1. Replace 33.2.11.1.2

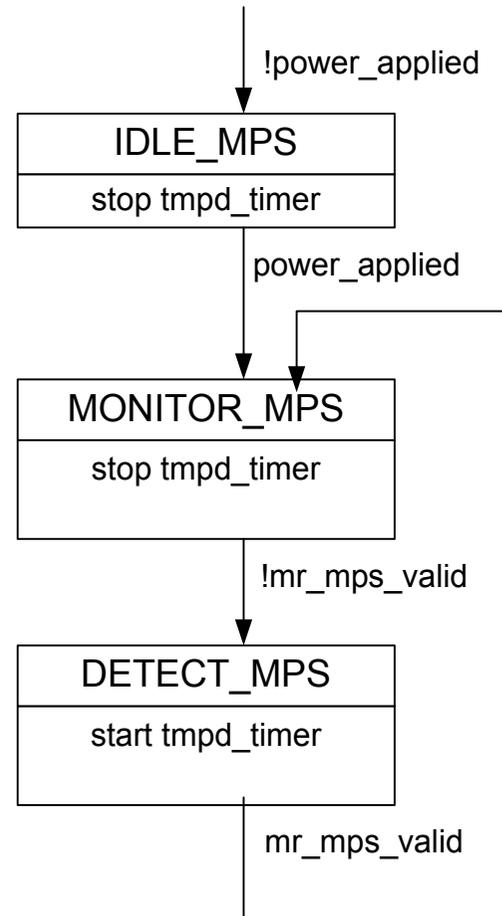
~~According to the state diagram in Figure 33-1.~~

A PSE shall consider the DC MPS to be TRUE, and PD present, if it detects that IPort is greater than or equal to IHLD max for at least TMPS min every TMPS min + TMPDO max. A pulsed DC MPS current allows PDs to decrease their minimum average power.

A PSE shall consider the DC MPS to be FALSE, and PD absent, if IPort is less than or equal to IHLD min for a duration greater than or equal to TMPDO min.

The specifications for TMPS in Table 33-11 applies only to the DC MPS component
